PUR-1401 ADDENDUM NO. 6 INVITATION TO BID

WASHINGTON COUNTY PUBLIC SAFETY TRAINING CENTER

DATE: Monday, September 14, 2020

1 EXTERIOR ELEVATION A2.3 1/8" = 1'-0"

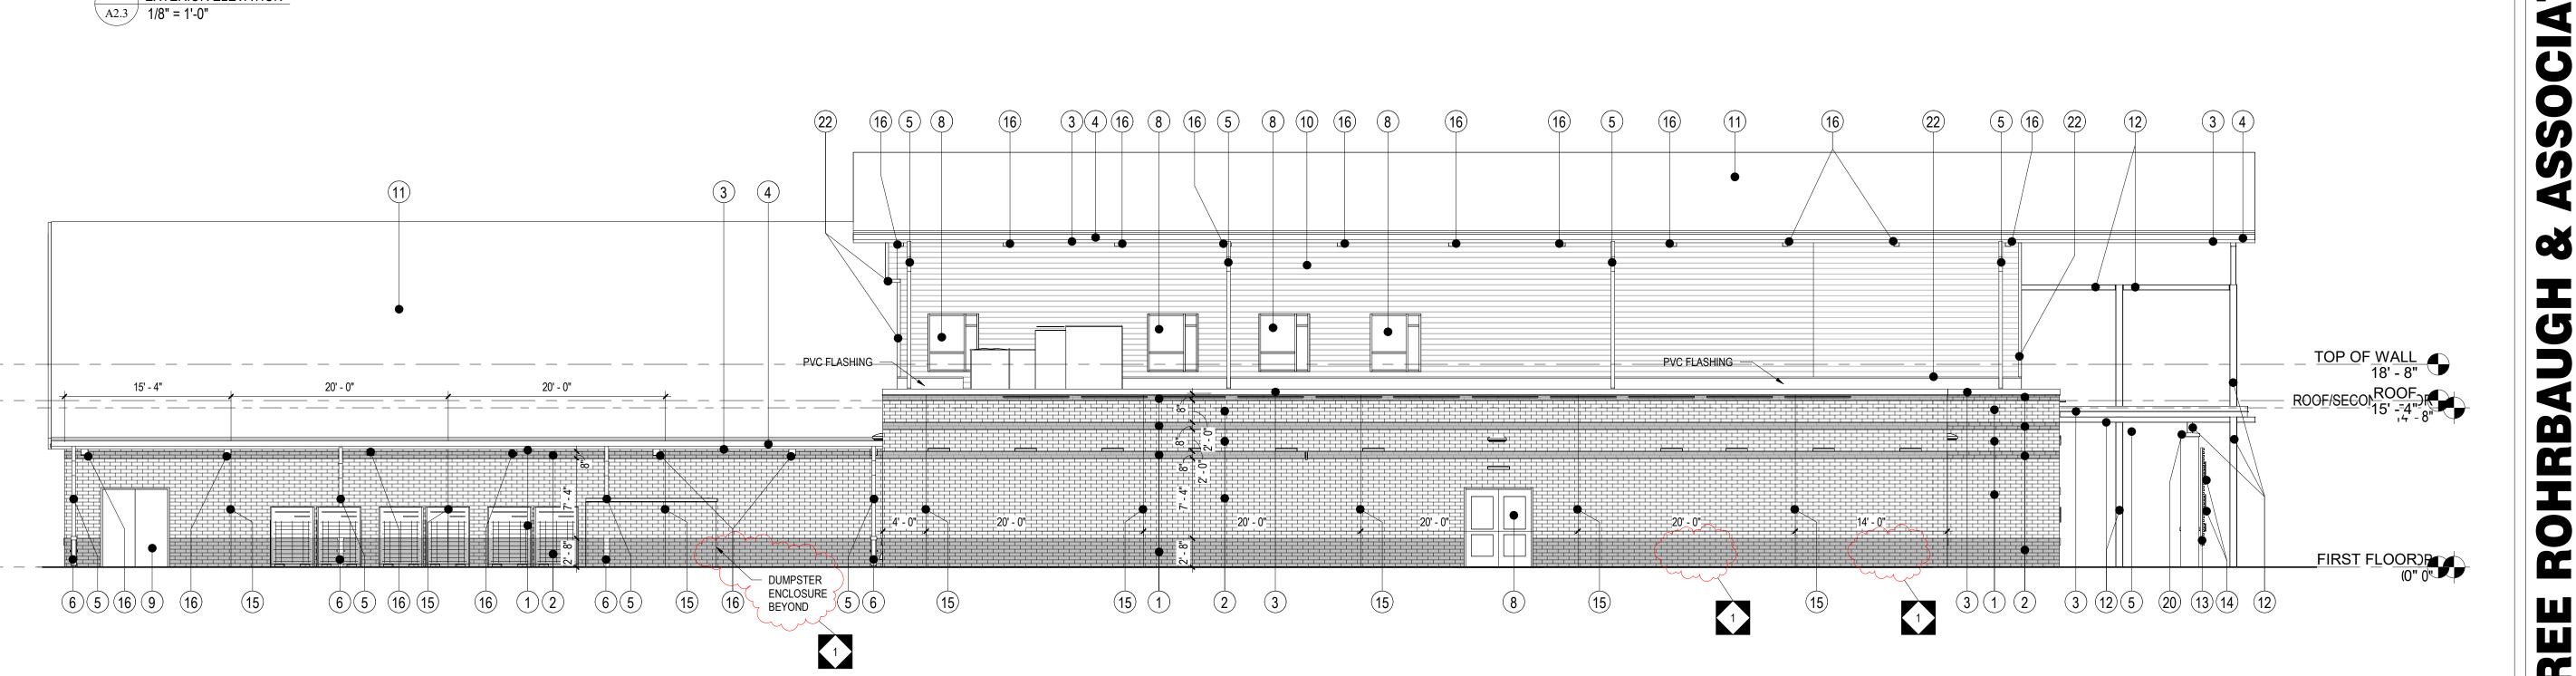
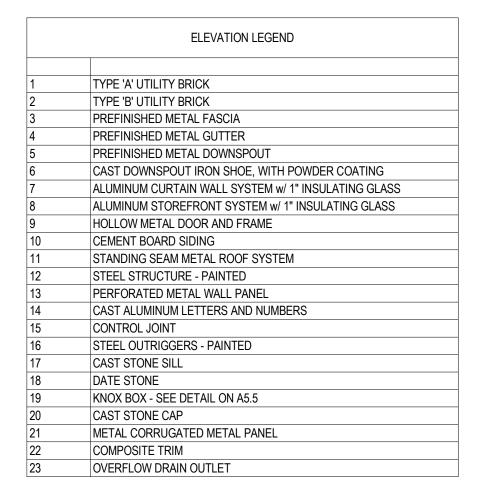
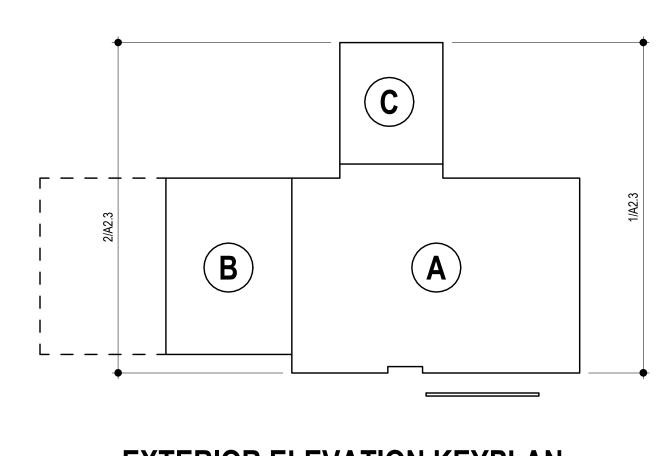
- ITEM NO. 23: <u>REVISION/CLARIFICATION</u>: Refer to Drawing A2.3, Exterior Elevations, Exterior Elevations 1 and 2/A2.3. Exterior elevations per attached revised drawing (Attachment B).

WALL SECTIONS PLOT SCALE:

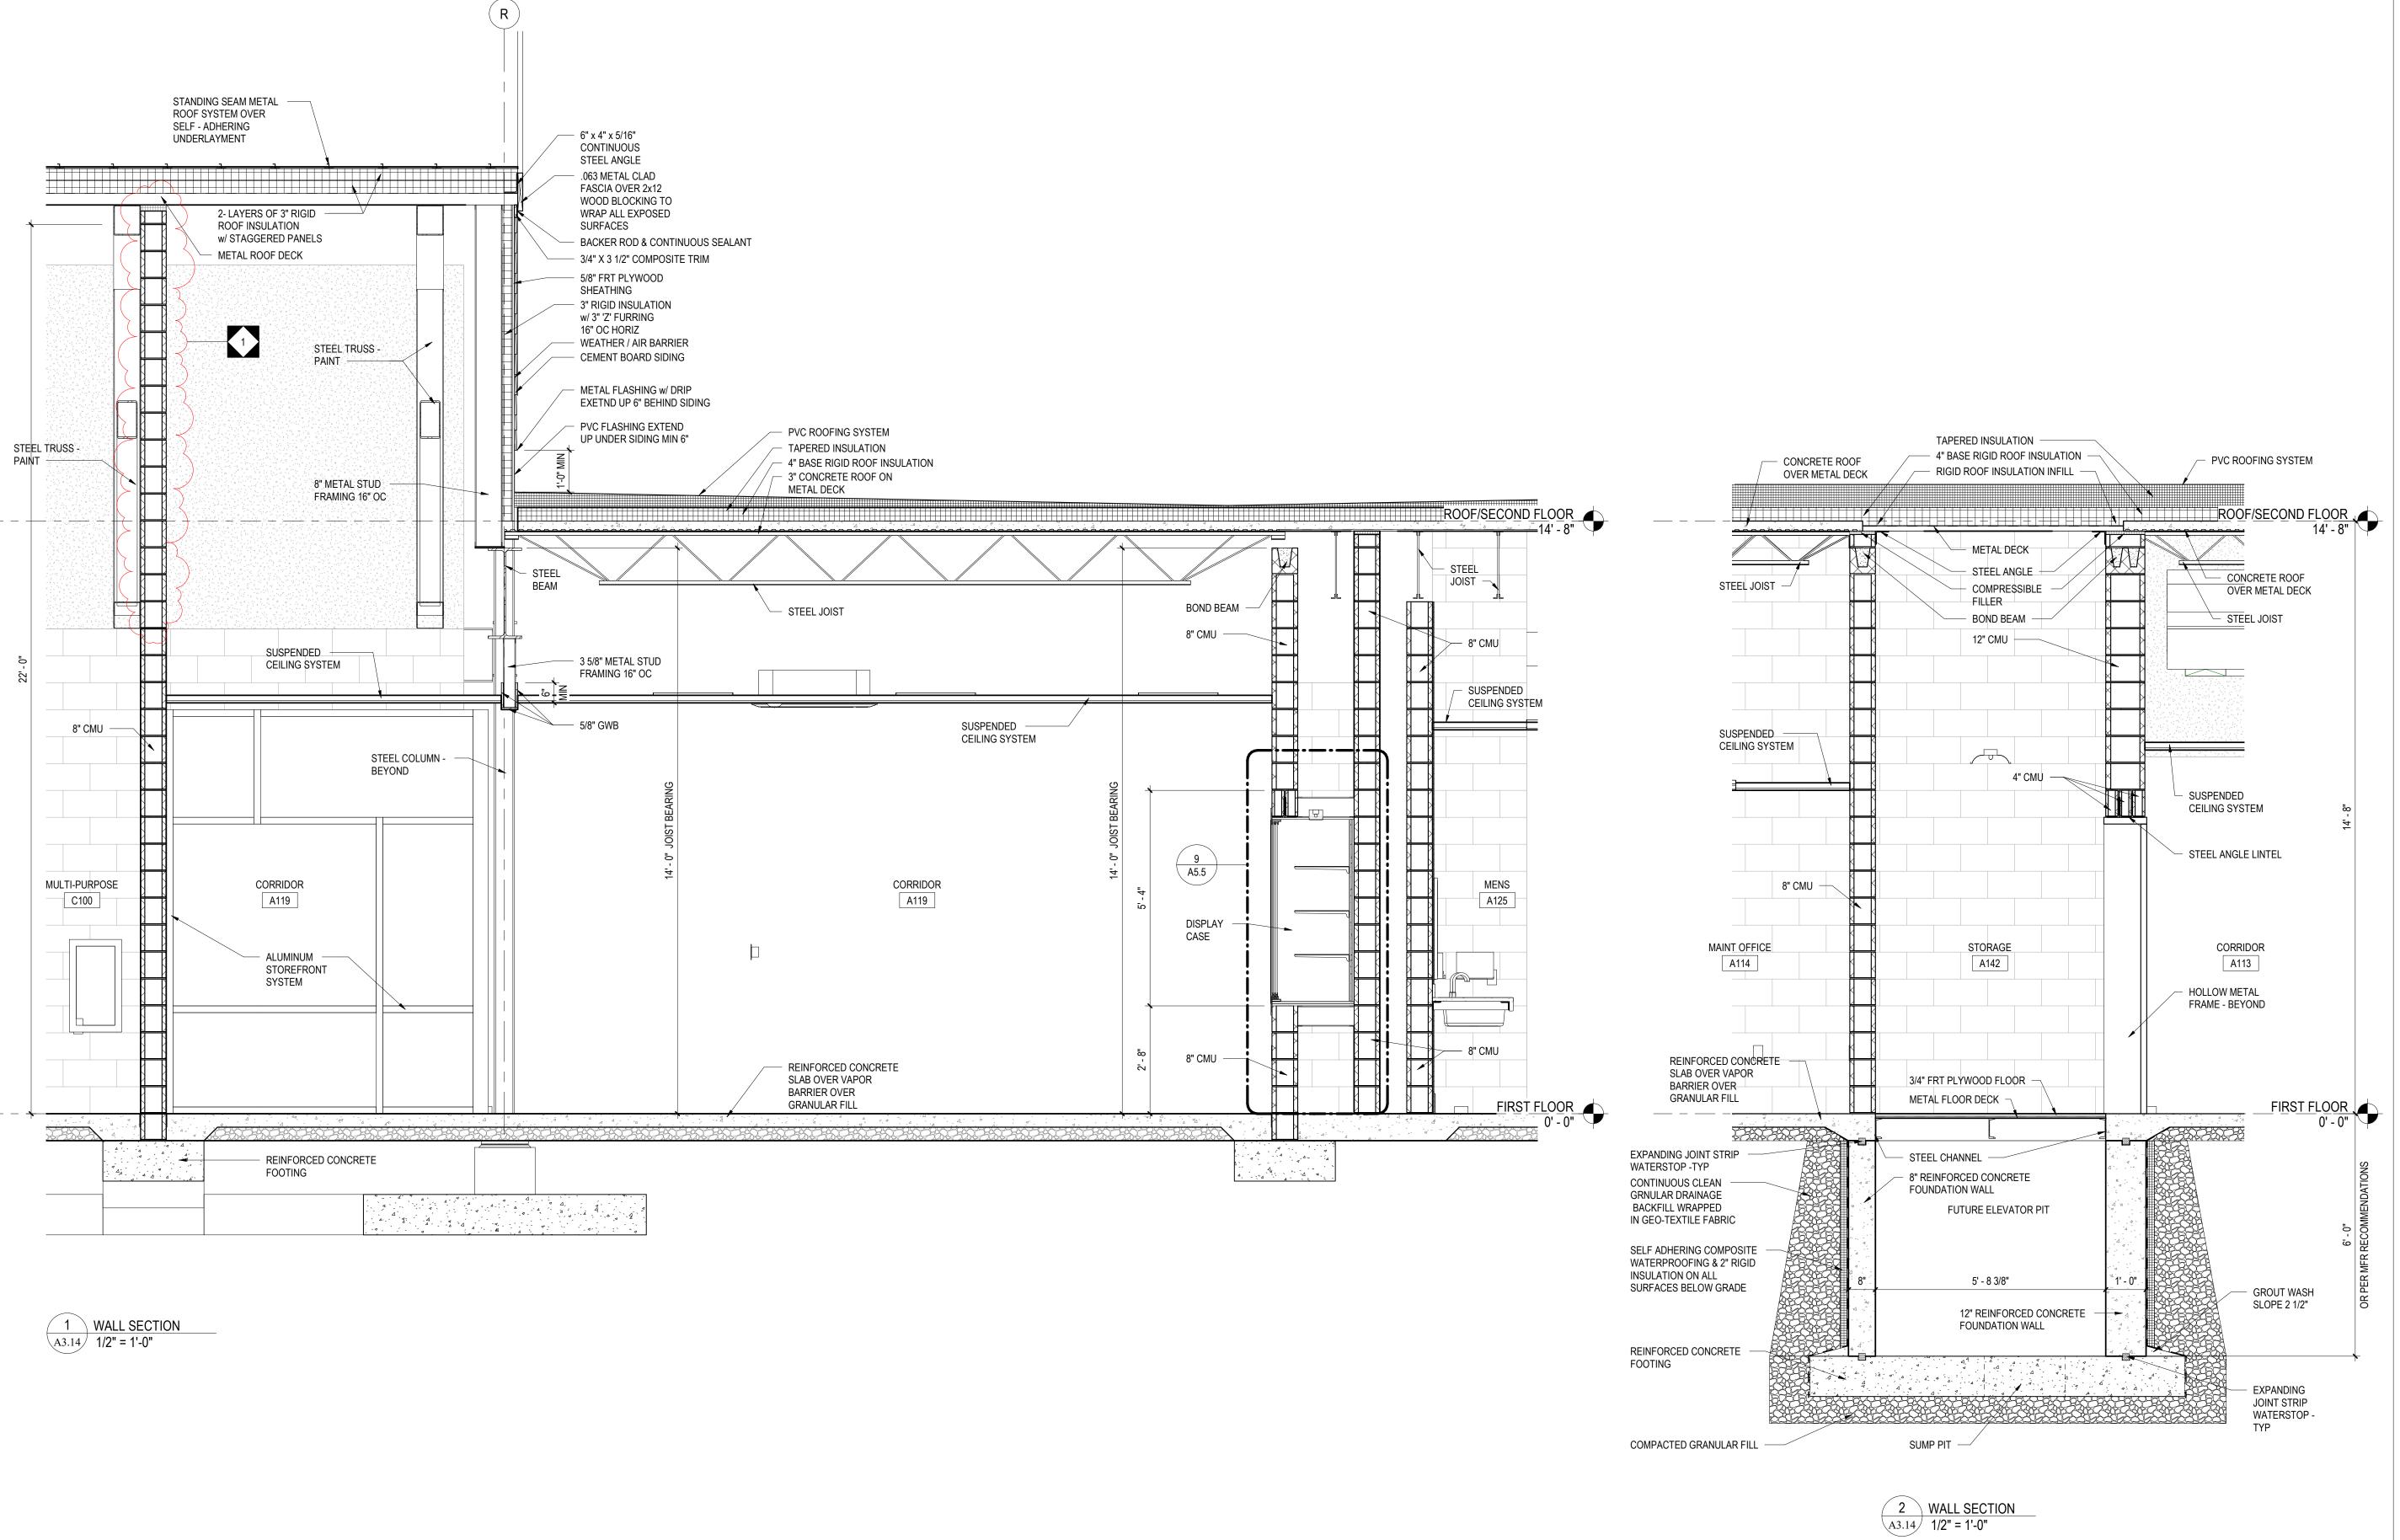
- ITEM NO. 24: Refer to Drawing A3.14, Wall Sections, Wall Section 1/A3.14; CHANGE, 8" CMU wall to extend to roof deck per attached revised drawing (Attachment C).

GUARDRAIL PLAN, **ELEVATION & DETAILS** As indicated

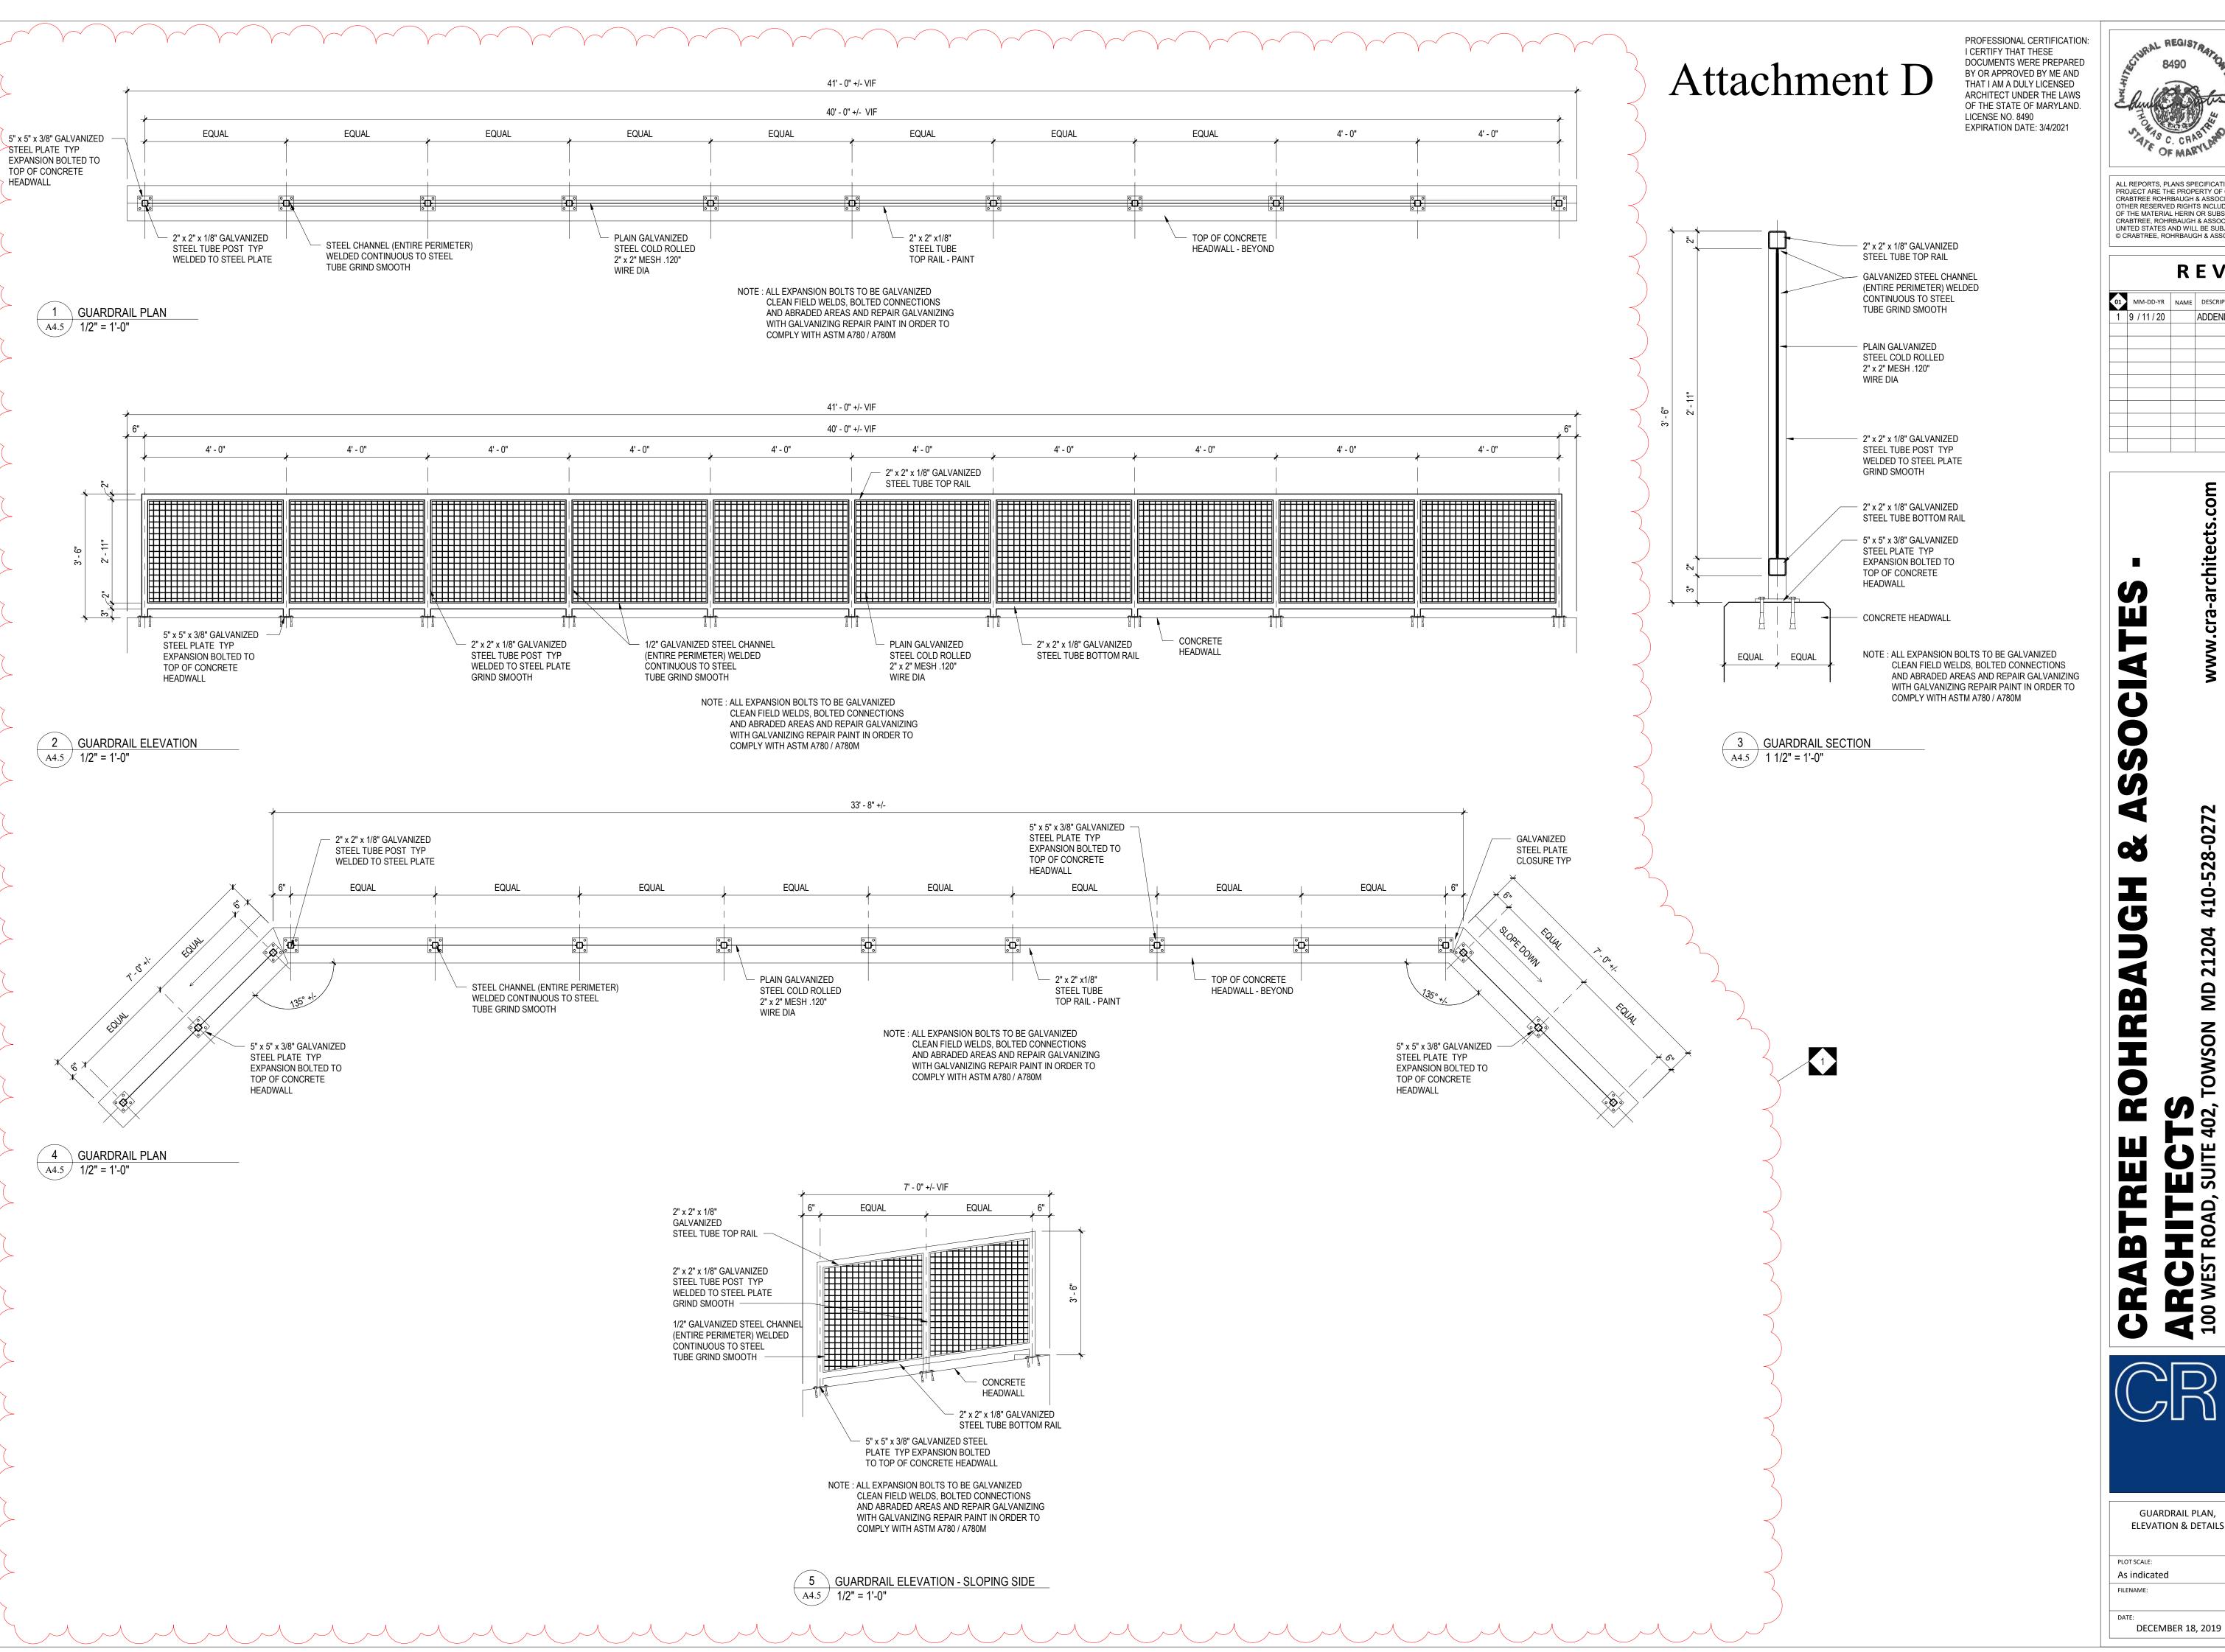
- ITEM NO. 26: <u>REVISION/ADDITION</u>: Refer to Drawing A4.5, Guardrail Plan, Elevation & Details; Elevations per attached revised drawing (Attachment D).
